# RENESAS TECHNICAL UPDATE

Product Category	MPU/MCU		Document No.	TN-RX*-A0239B/E	Rev.	2.00
Title	RX210 Group Errata to User's Manual: Hardware Regarding the Realtime Clock (RTC)		Information Category	Technical Notification		
Applicable Product	RX210 Group	Lot No.	Reference Document	RX210 Group User's Manual: Hardware Rev.1.50 (R01UH0037EJ0150)		
		All

This document describes corrections to the "Realtime Clock (RTC)" chapter in User's Manual: Hardware for the applicable products.

Figure 26.3 Clock Setting Procedure

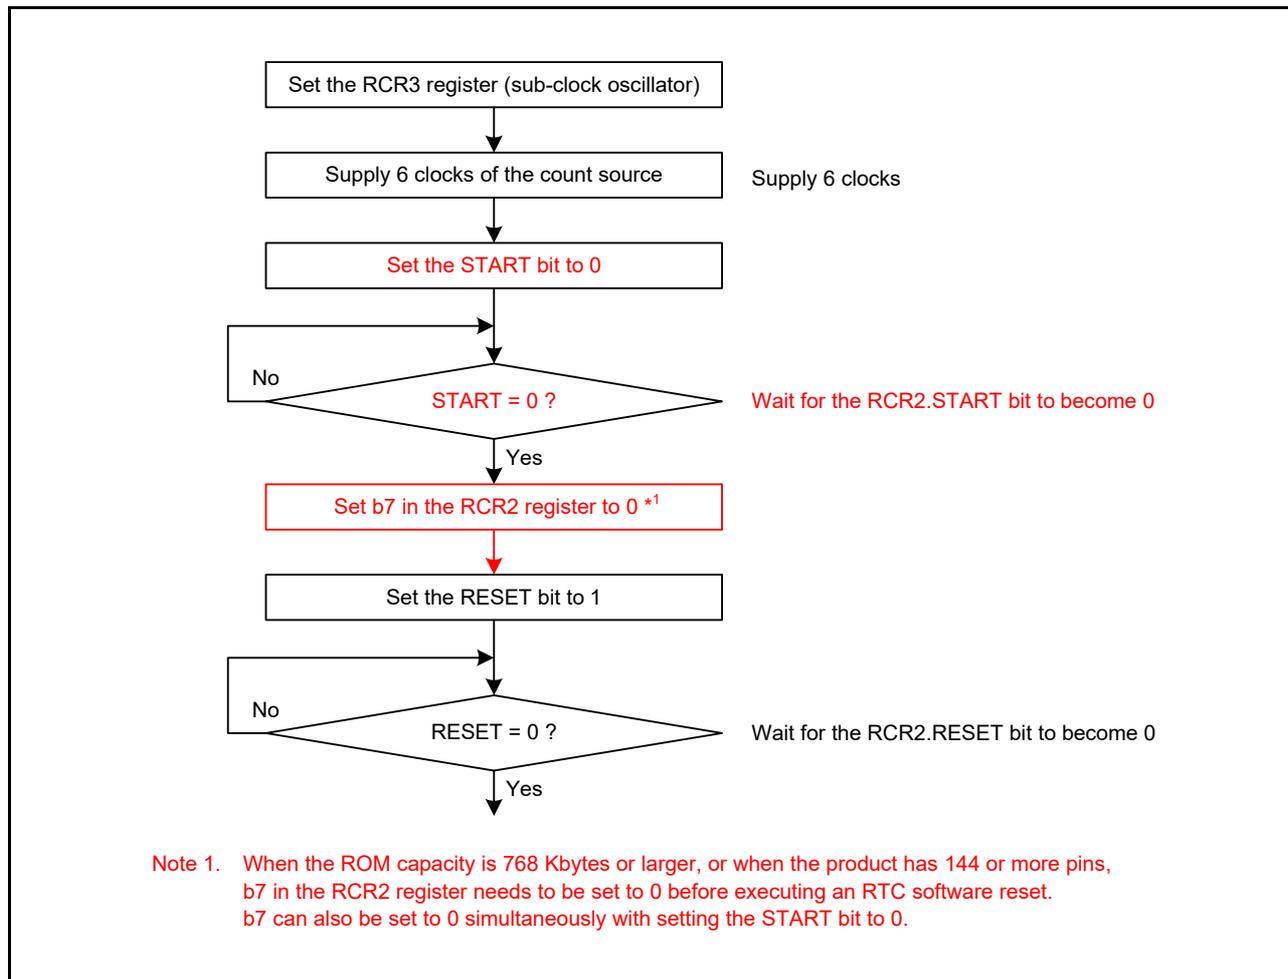
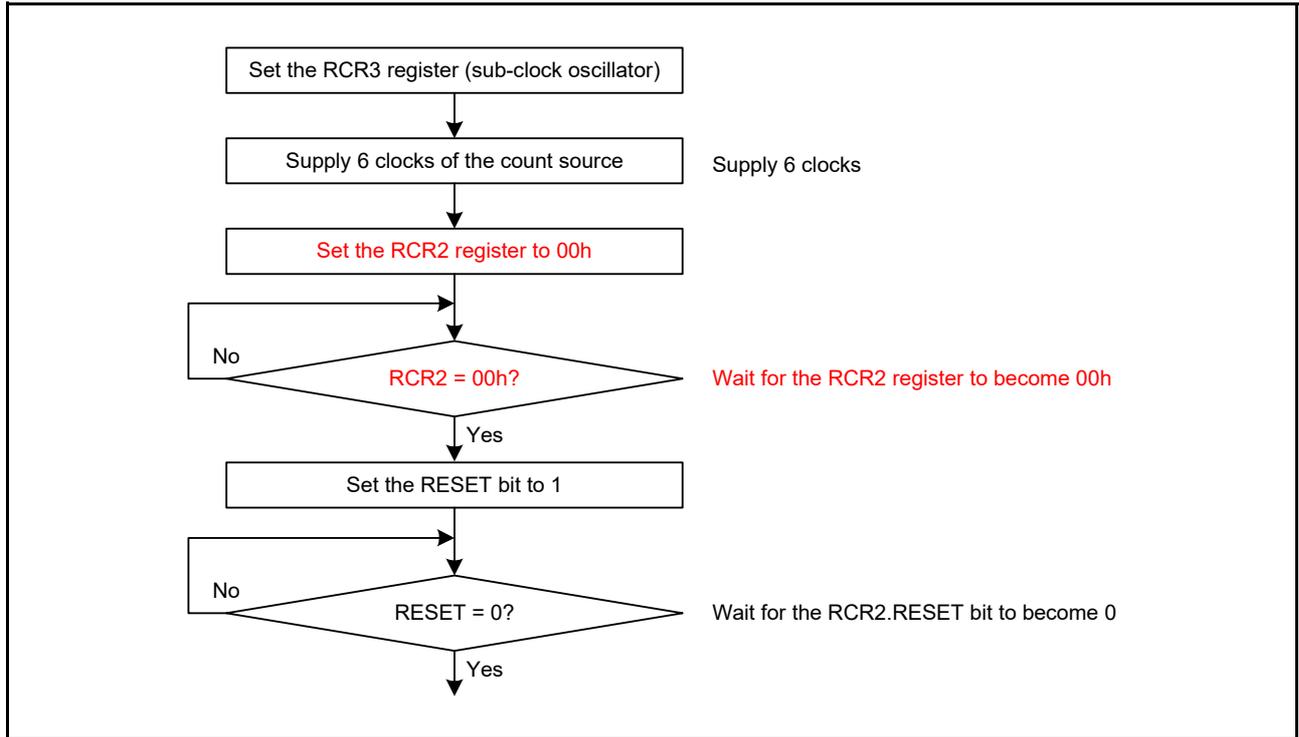
The setting procedure described in Figure 26.3, Clock Setting Procedure is corrected as follows.
